Town of Rolesville, NC
Department of Planning

Comments on #SDP-26-0008 - Planning & Zoning: Site Development Plan

Application Number: #SDP-26-0008
Application Type: Site Development Plan
Date: September 11, 2026
Address: 408 E YOUNG ST, ROLESVILLE, NC 27571
Parcel: 1768098727

CID-25-07 | ROLESVILLE PLAN CASE # SDP-26-0008

SHEET NUMBER:
C-0.00

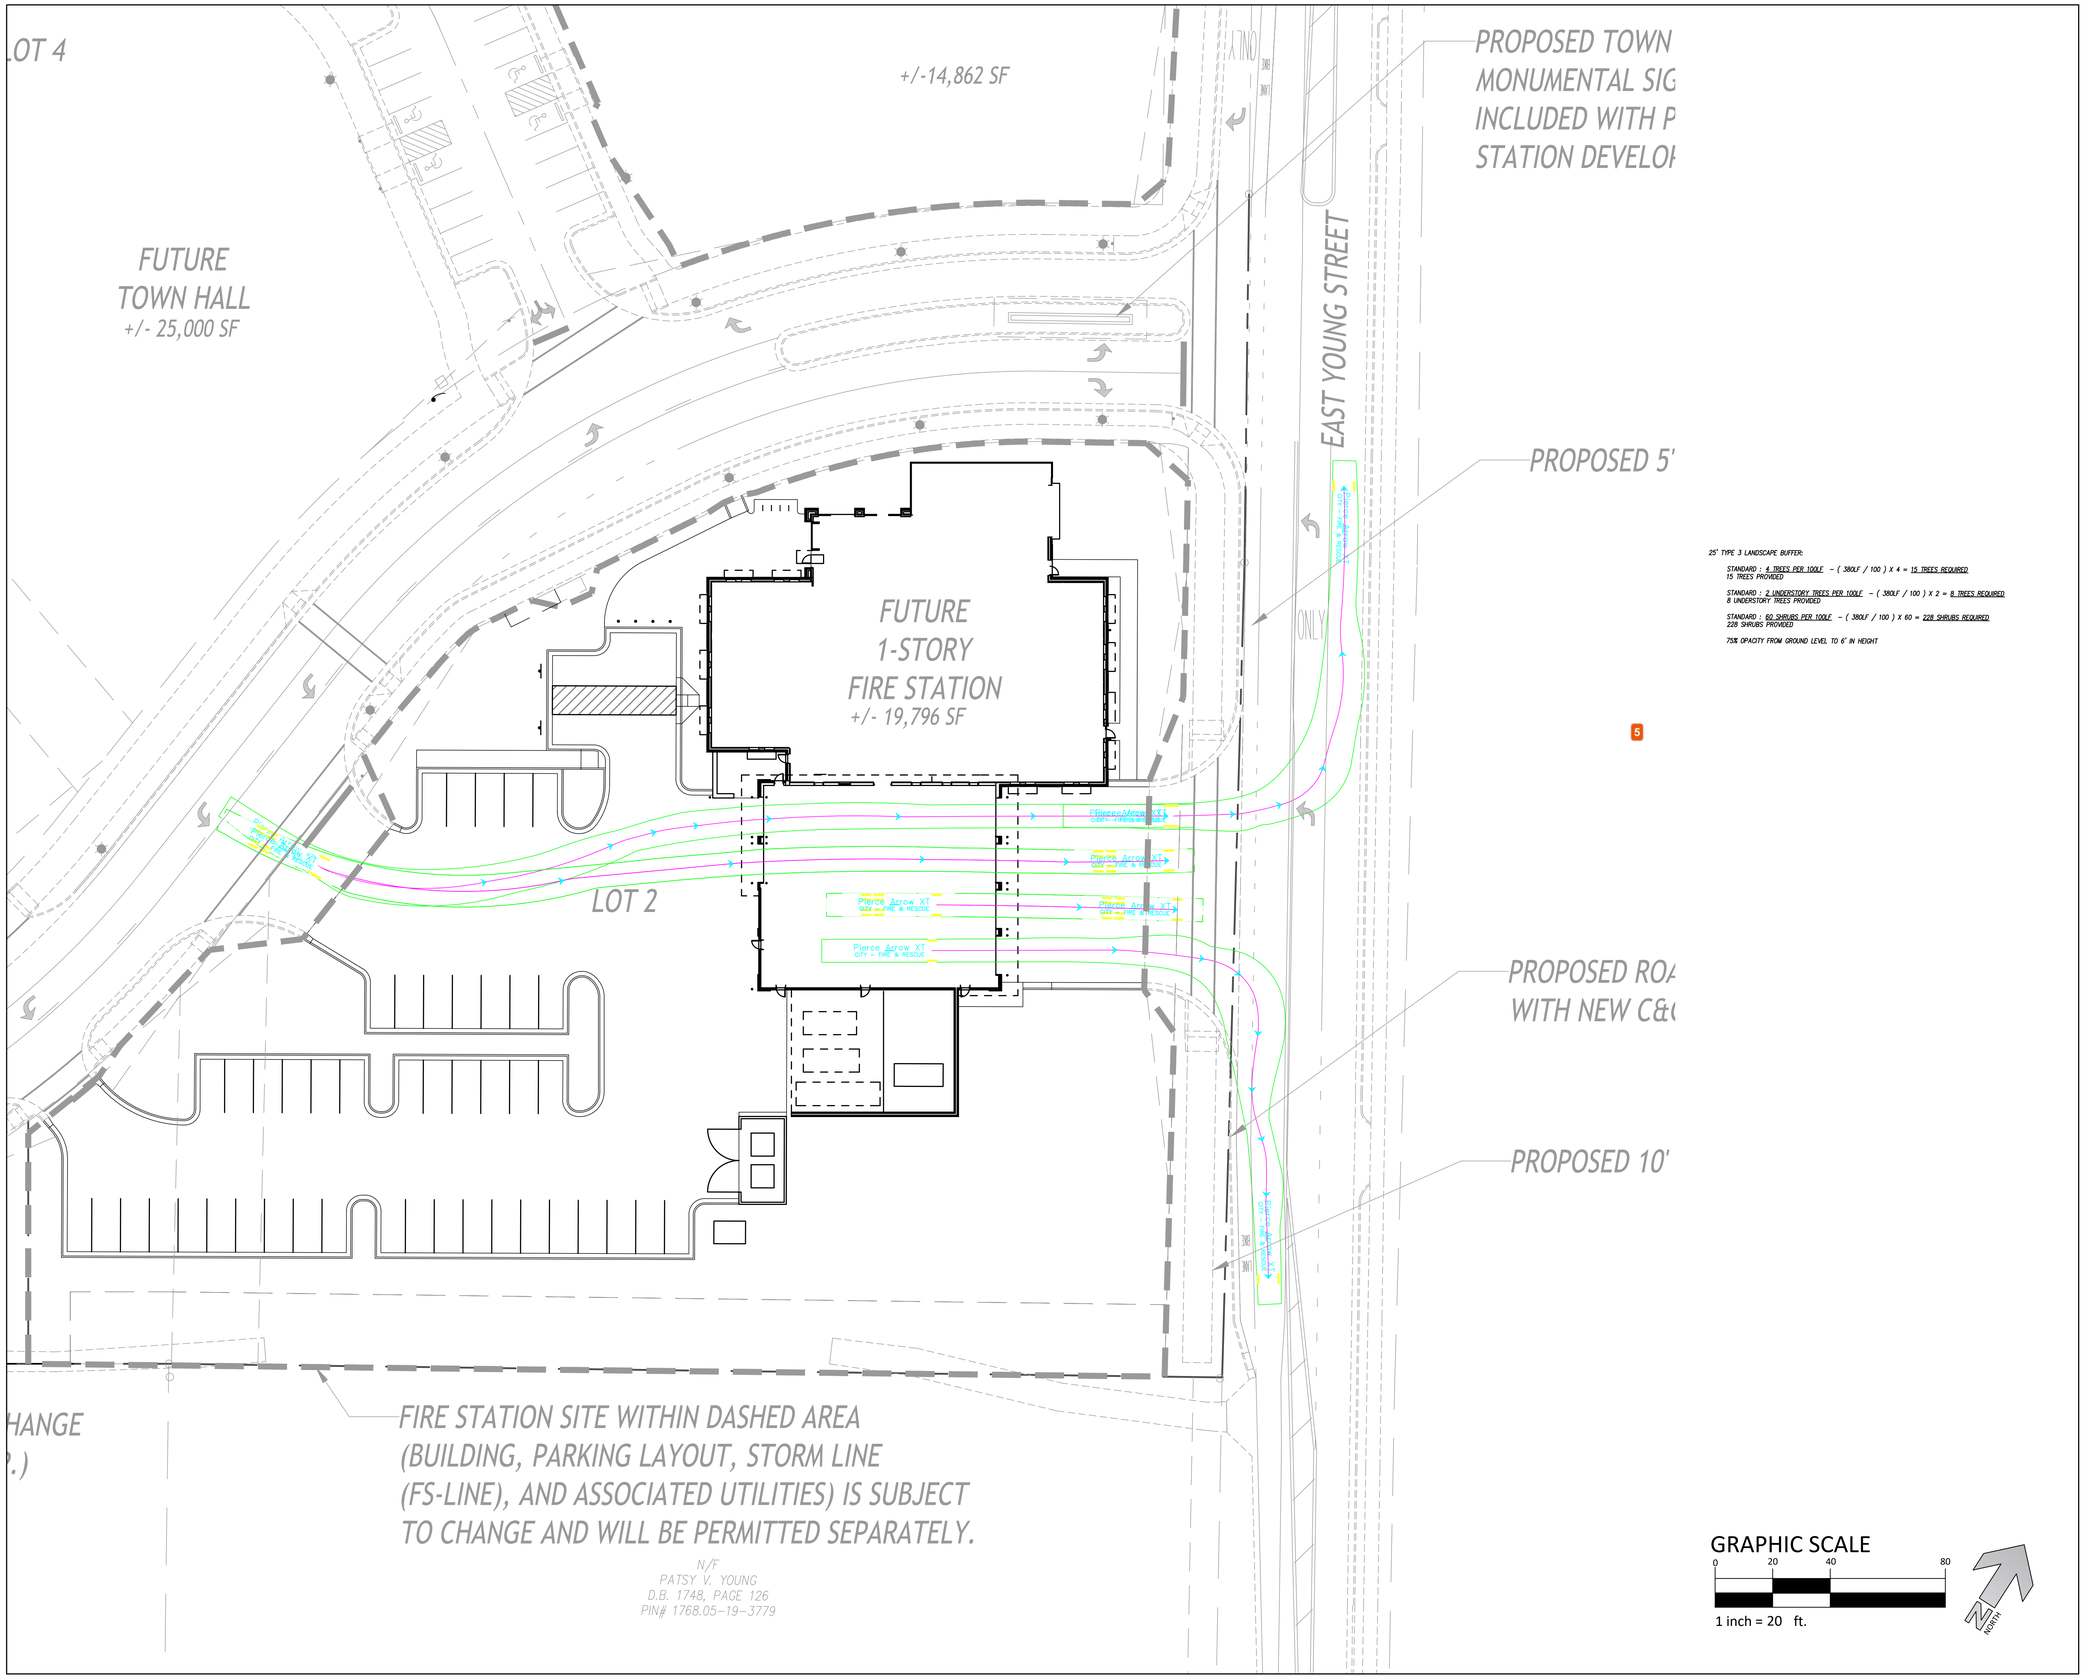
1 **Stephen Wensman**
The Site Plan Checklist states that a Lighting Plan is required per LDO Section 6.6.F, but the Lighting Plan section of the checklist is left blank and no Lighting Plan was included in the submitted plan set. Please provide a Lighting Plan prepared, signed, and sealed by a licensed engineer, and update the checklist accordingly.

2 **Michael Elabarger**
This Cover sheet looks a little different than that for POlice - they should be identical in arrangement etc as they are the same thing (SDP). please learn from the other SDP and vice versa to be consistent - TY!

4 **Stephen Wensman**
TAs are not entitlements - please remove

SHEET NUMBER:
C-0.02

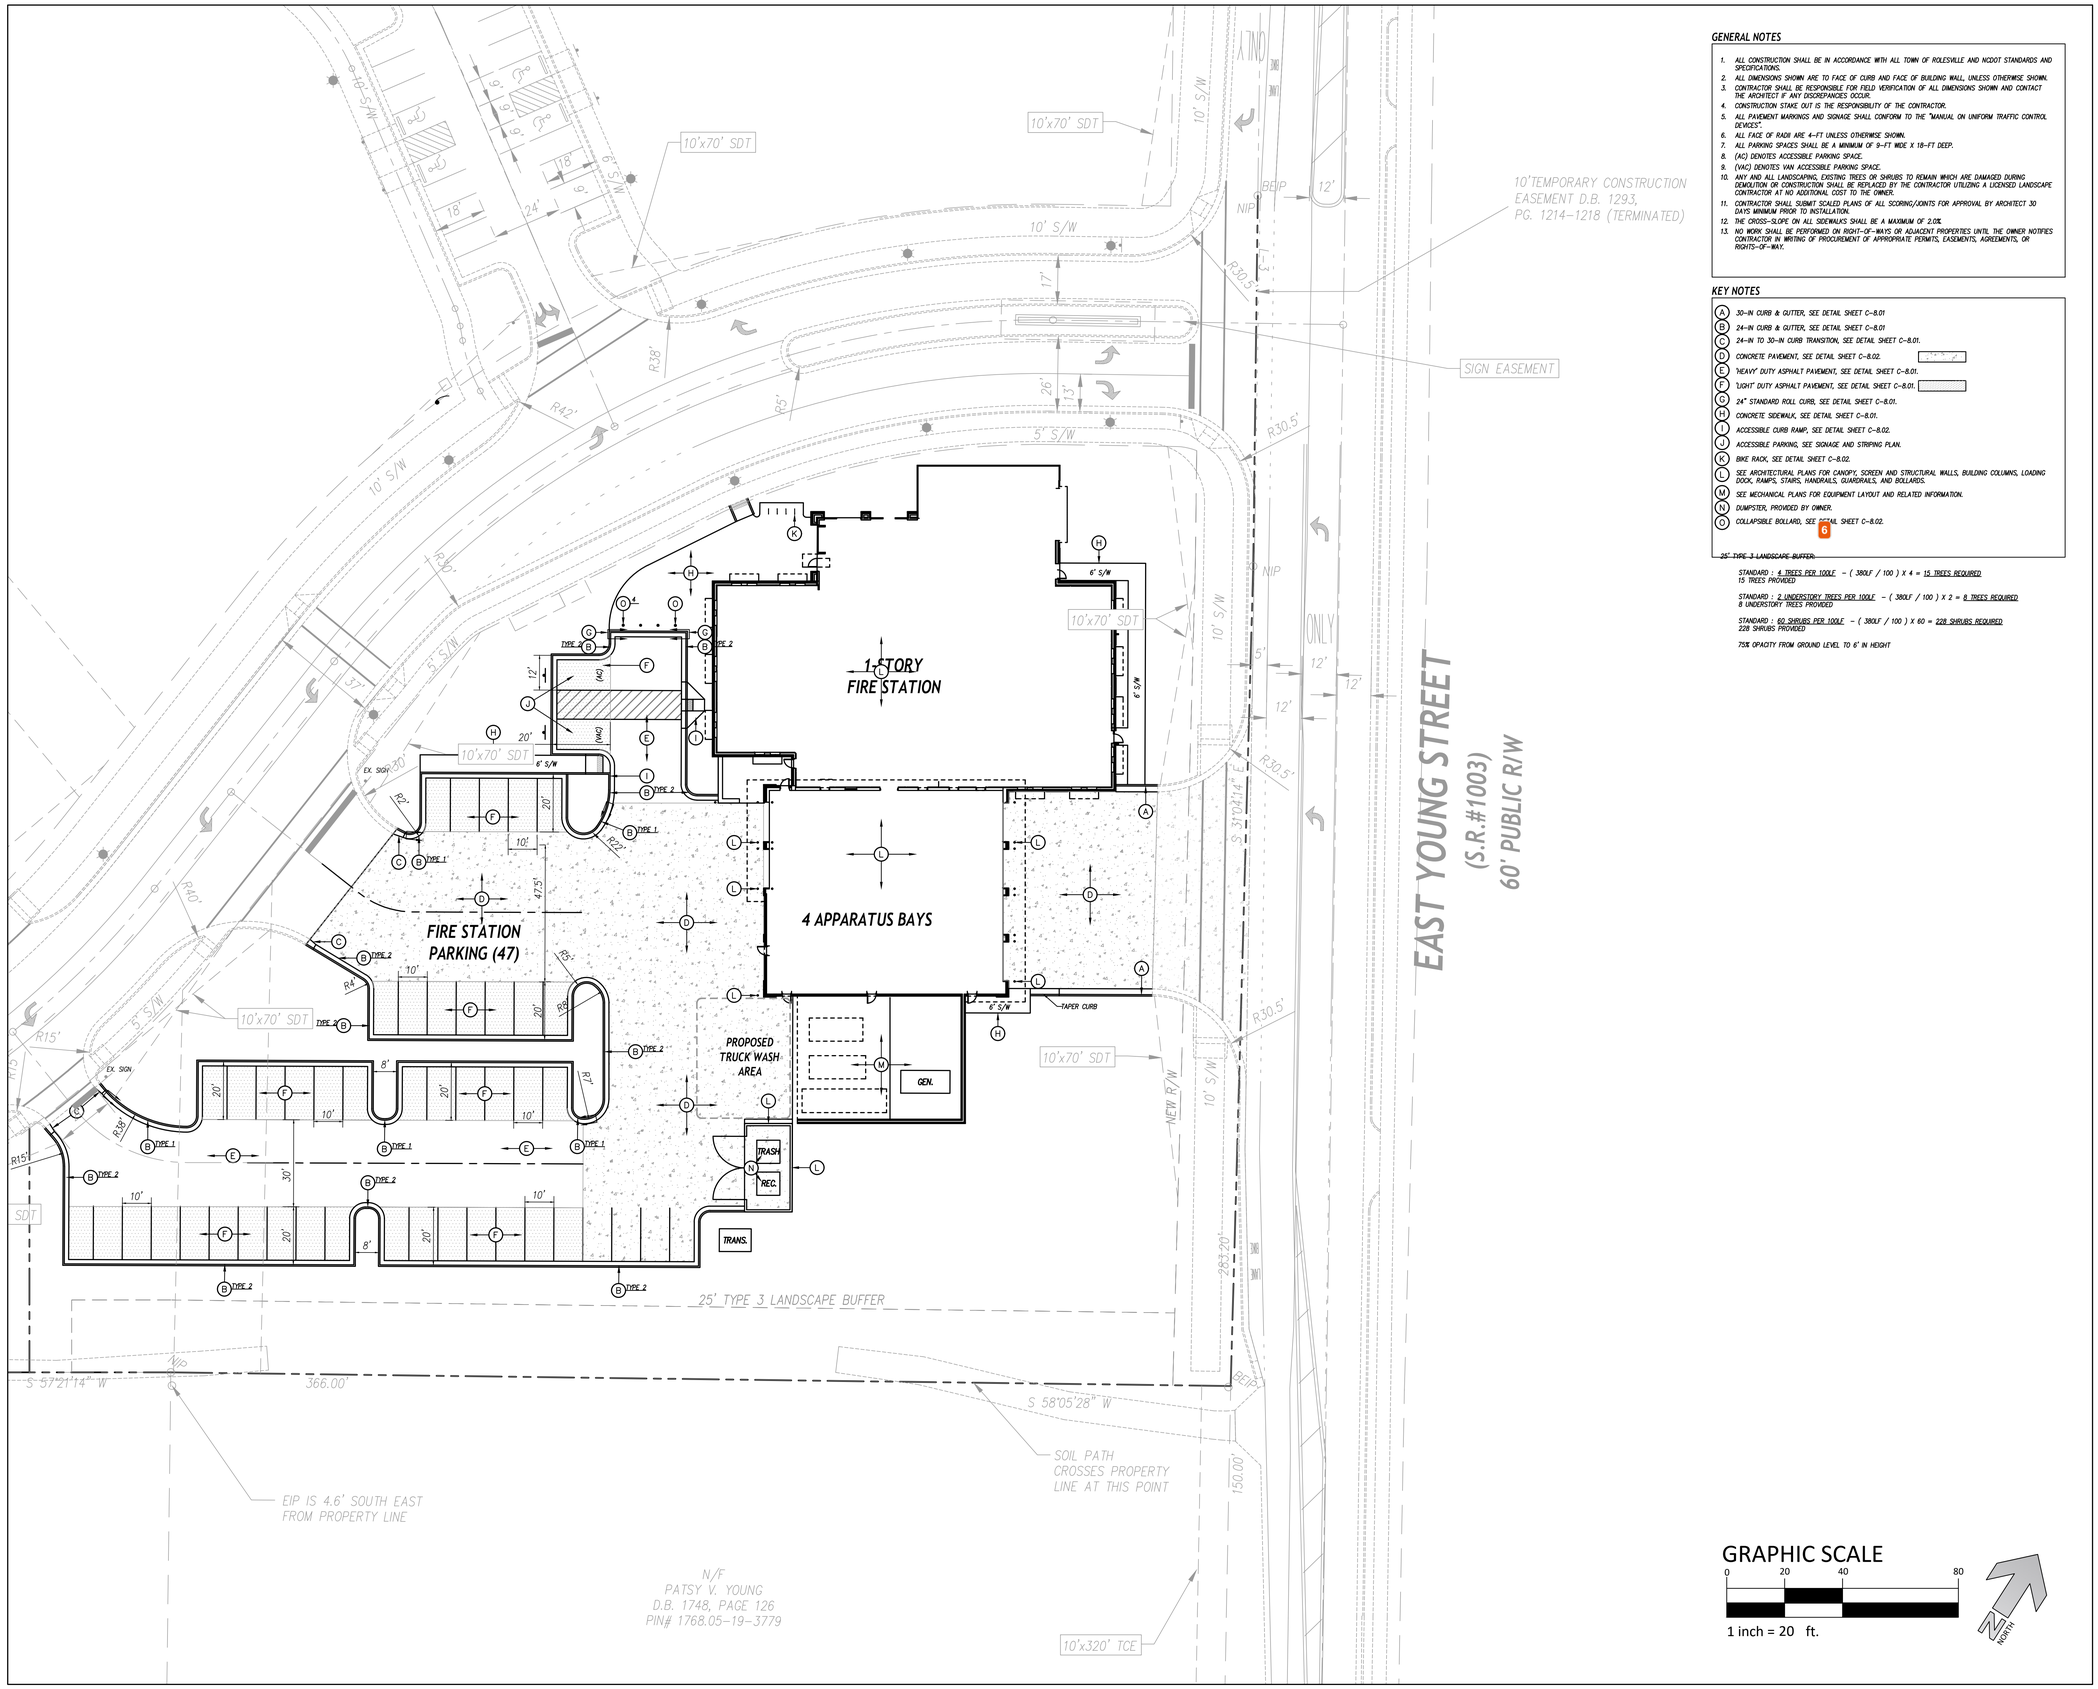
5 **Stephen Wolf**
** Plans are preliminary and not for construction. The address listed is for the entire site. Please provide Wake County GIS approved address when building plans are submitted.
** Plans are preliminary and not for construction. Please include fire line, FDC, and all fire hydrant information on the next submittal. Plans will be reviewed once stamped construction drawings are submitted.

SHEET NUMBER:
C-1.01

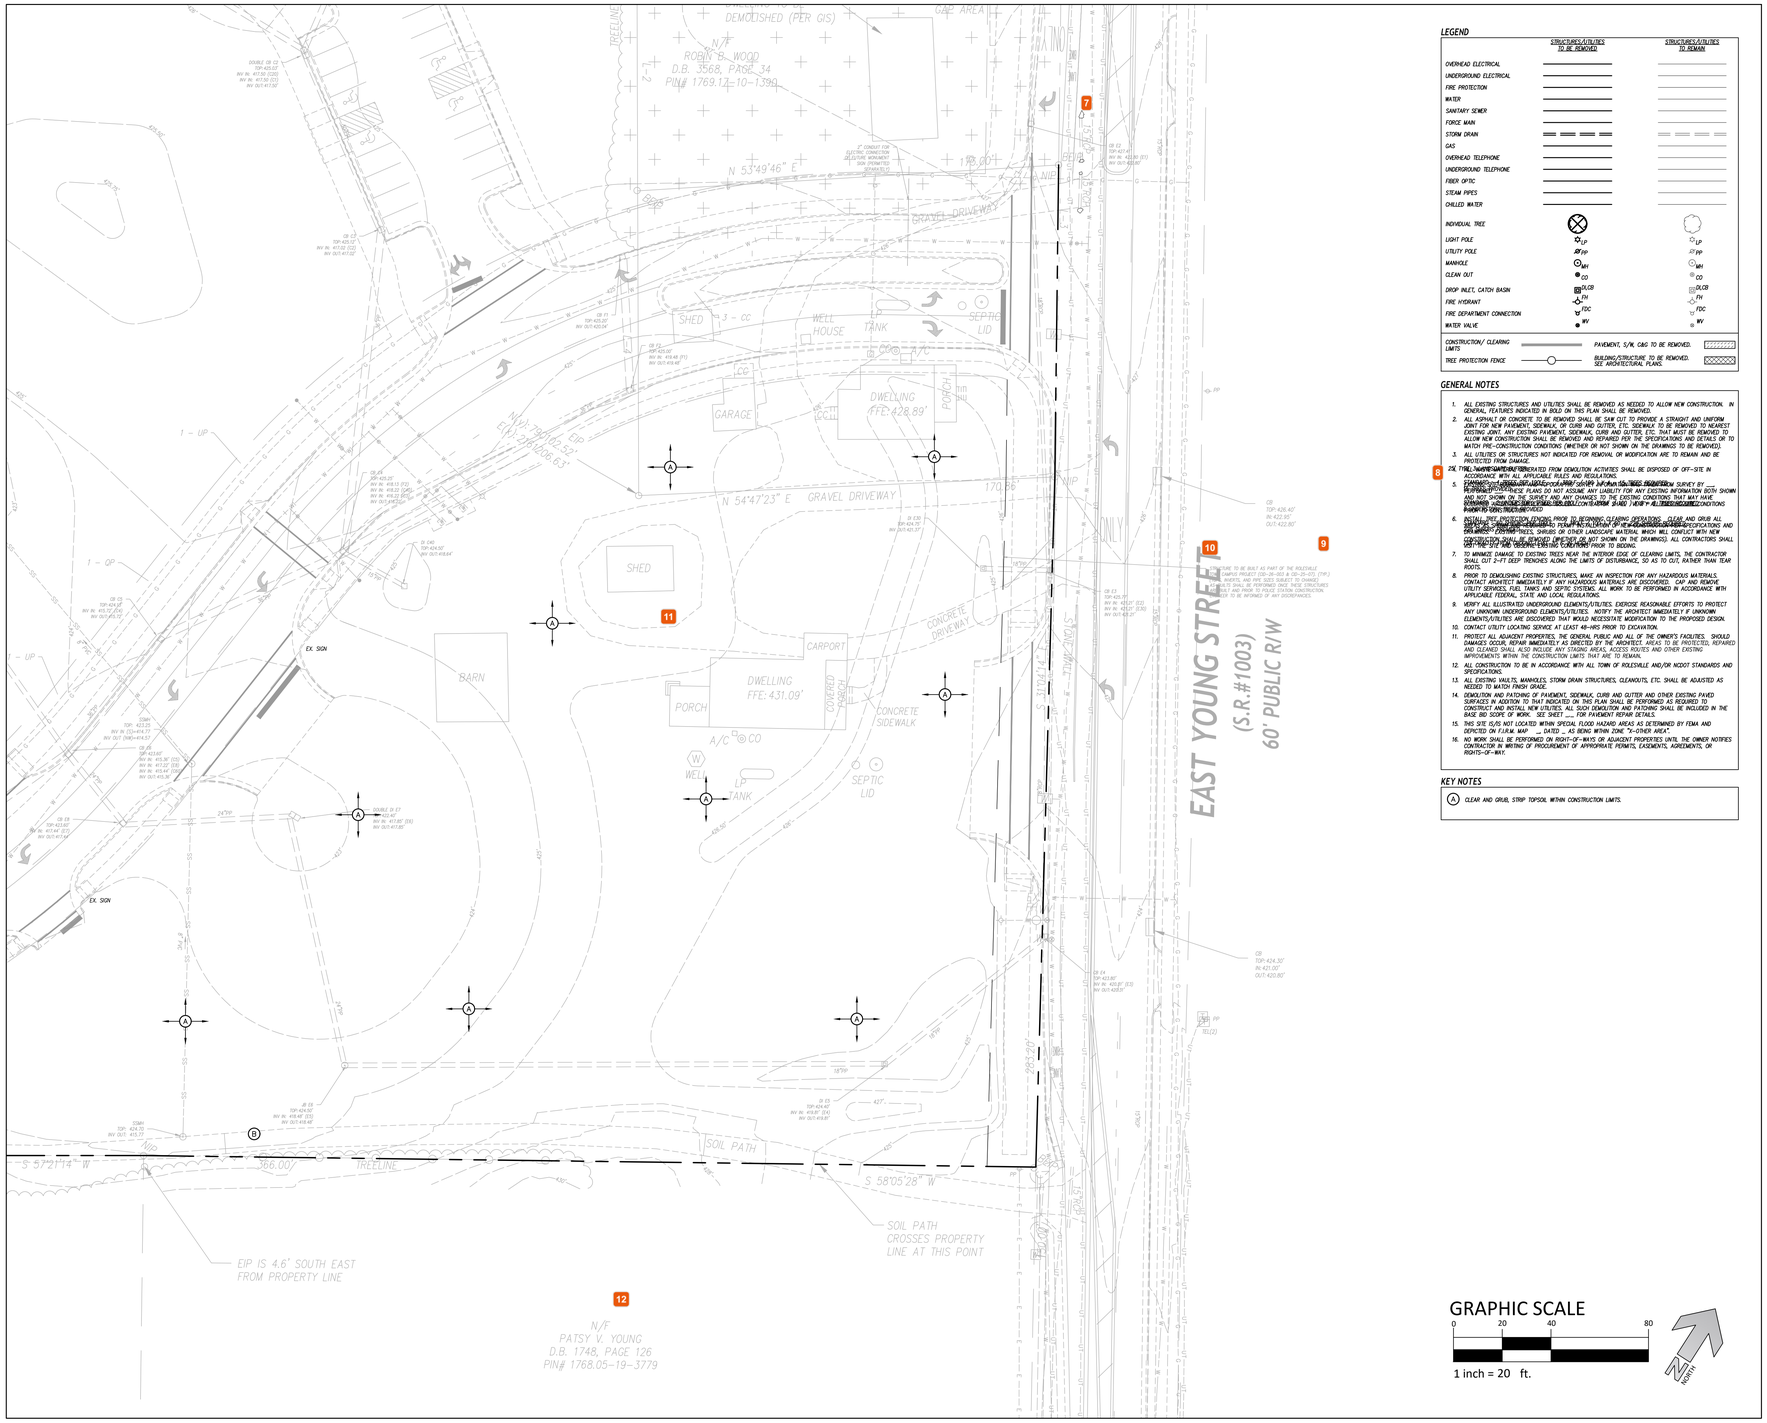
6 Jacqueline Thompson
Adjust text to avoid overlap for legibility
